**LAKE PONTCHARTRAIN,  
LOUISIANA, AND VICINITY  
HURRICANE PROTECTION  
PROJECT**

*REEVALUATION STUDY*

**PUBLIC VIEWS AND  
RESPONSES APPENDIX**

**APPENDIX D**  
**PUBLIC VIEWS AND RESPONSES**  
**TABLE OF CONTENTS**

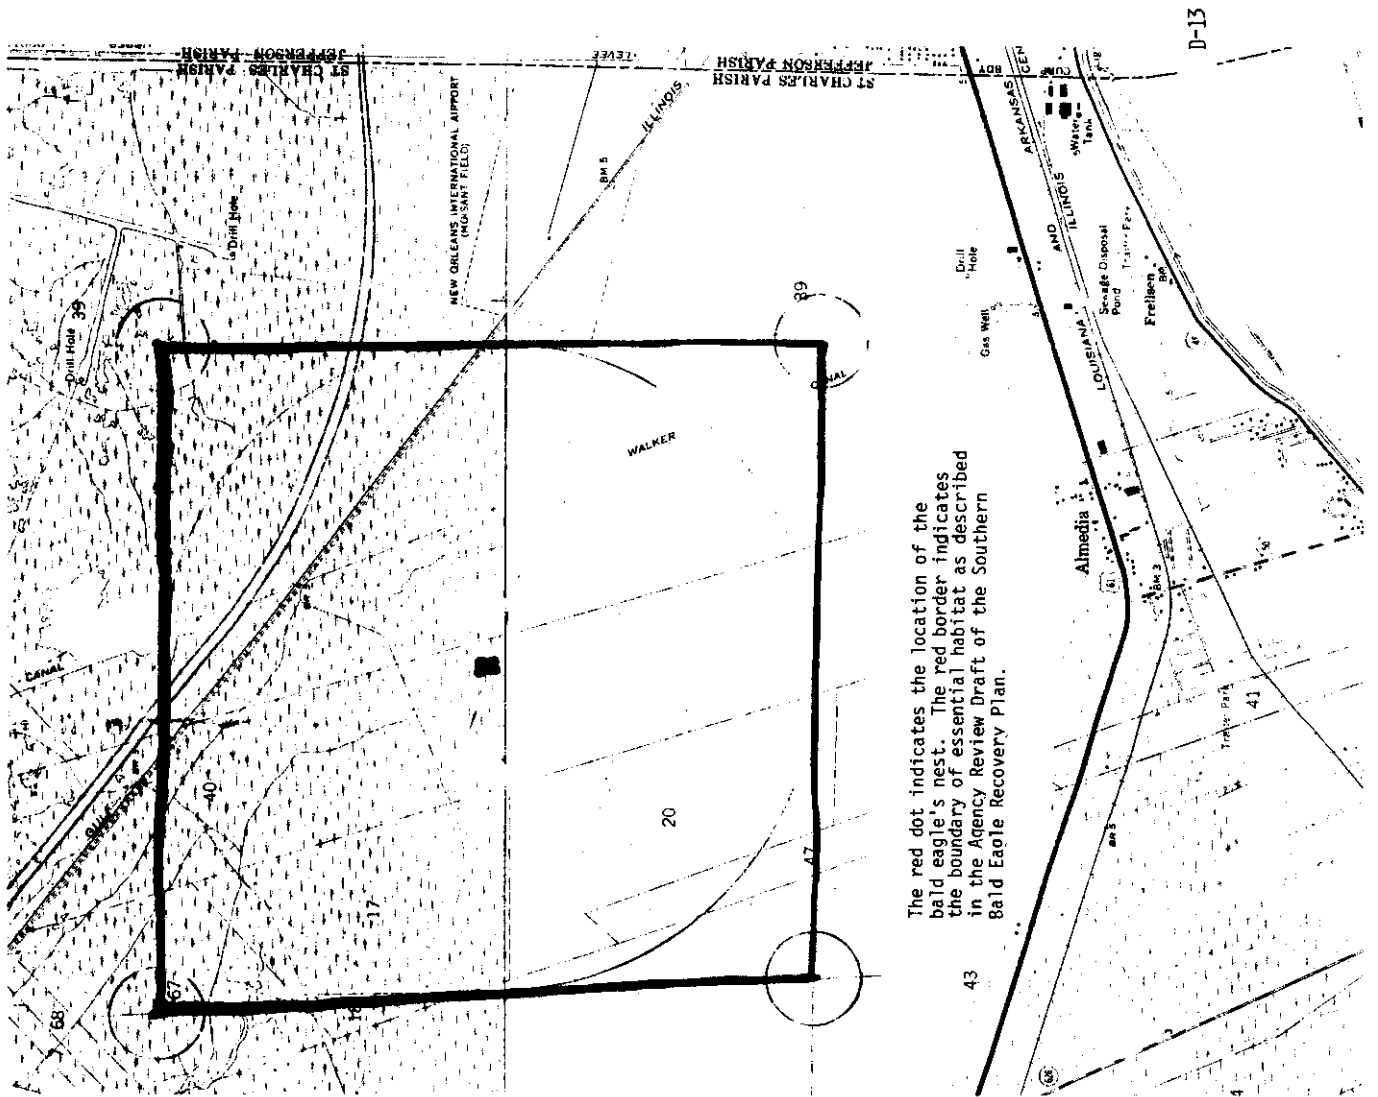
This refers to your November 19, 1981, letter regarding the Biological Assessment on the Lake Pontchartrain and Vicinity Hurricane Protection Project and to the Draft Main Report and Draft Supplement to the Environmental Impact Statement (EIS) for the Lake Pontchartrain, Louisiana, and Vicinity Hurricane Protection Project, Reevaluation study. The subject assessment states that the tentatively selected High Level Plan would have no adverse impact on the bald eagle. This assessment also provides a map of the proposed levee alignment. It has come to our attention that there is now a new bald eagle nest located between Interstate 10 and Air-Line Highway (61) and near the St. Charles, Jefferson Parish Line (see the attached figure). This places the nest in the vicinity of the proposed levee location.

The levee alignment in this area as indicated on Figure 1 of the assessment leads this office to believe that the proposed alignment is more than one mile from the subject nest and is unlikely to affect the nesting eagles. However, plate 9 of the EIS indicates that the proposed alignment may be very close to the eagle nest.

We recommend that you revise your biological assessment to:

- 1) clarify the location of the proposed alignment in regard to the eagle's nest;
- 2) discuss the adverse impact of the selected alignment upon these nesting eagles; and
- 3) determine if the project may affect the bald eagle.

The red dot indicates the location of the bald eagle's nest. The red border indicates the boundary of essential habitat as described in the Agency Review Draft of the Southern Bald Eagle Recovery Plan.

RESPONSE 6.1: The biological assessment in Appendix C, Section 1 has been revised accordingly.
